**DA NO:** DA-2023/101

**ADDRESS:** 61 SUGARLOAF CRESCENT, CASTLECRAG NSW 2068.

**PROPOSAL:** DEMOLITION OF EXISTING DWELLING AND CARPORT AND CONSTRUCTION OF NEW DWELLING HOUSE, SWIMMING POOL, OUTDOOR ENTERTAINING AREA, DOUBLE GARAGE, LANDSCAPING AND ASSOCIATED WORKS.

Figure 5: Overlay of survey and site plans

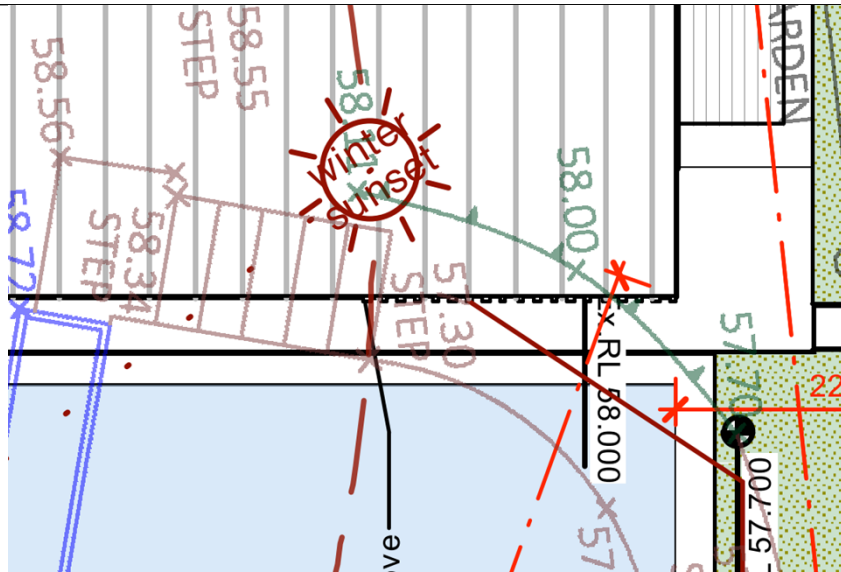
Building height	<p>Concerns were raised that the building height was not provided accurately. Plan 3.05 was provided post lodgement to display the accurate height of the proposal, displaying compliance against the 8.5m height limit.</p> <p>The RL of the roof is 65.8 whilst the lowest existing ground level below the roof being 57.3. This is confirmed via overlay of the survey and site plan.</p>

Figure 12 : Location of bedroom highlighted in yellow

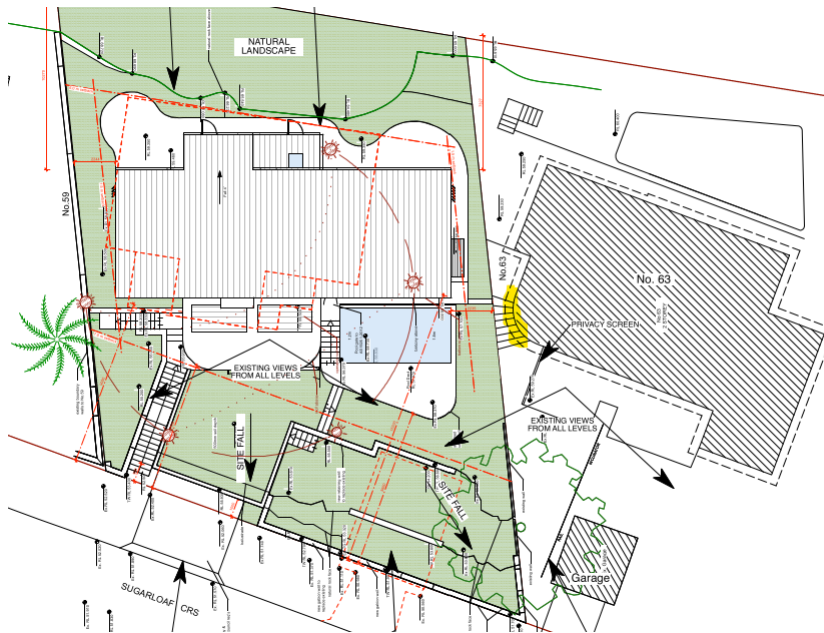
Assessment: The views affected are obtained diagonally across the eastern side boundary of 63 Sugarloaf Crescent from a bedroom, looking in an eastern direction. All are viewed from a standing position in the dwelling.

The potential view loss is deemed to be of a negligible manner. Obstruction to views from bedrooms are not deemed to be of the same value as active spaces. It is noted that 63 Sugarloaf Crescent contains a large alfresco area at the front of the dwelling which obtains views of natural vegetation of Harold Reid Reserve.

Assessment: The subject site is severely constrained by its irregular shape and steep slope. Despite this, the proposal contains a compliant FSR and height, and is largely compliant with the *DCP* numerical controls for dwellings except for the building height plane control. It is also noted that the proposed ground and first floor of the development is located behind the subject bedroom window, with the proposal pool and deck being located below the FFL of the bedroom.

As such, it is concluded that the impact to the views from the adjoining property at 63 Sugarloaf Crescent is considered to be minor and acceptable.
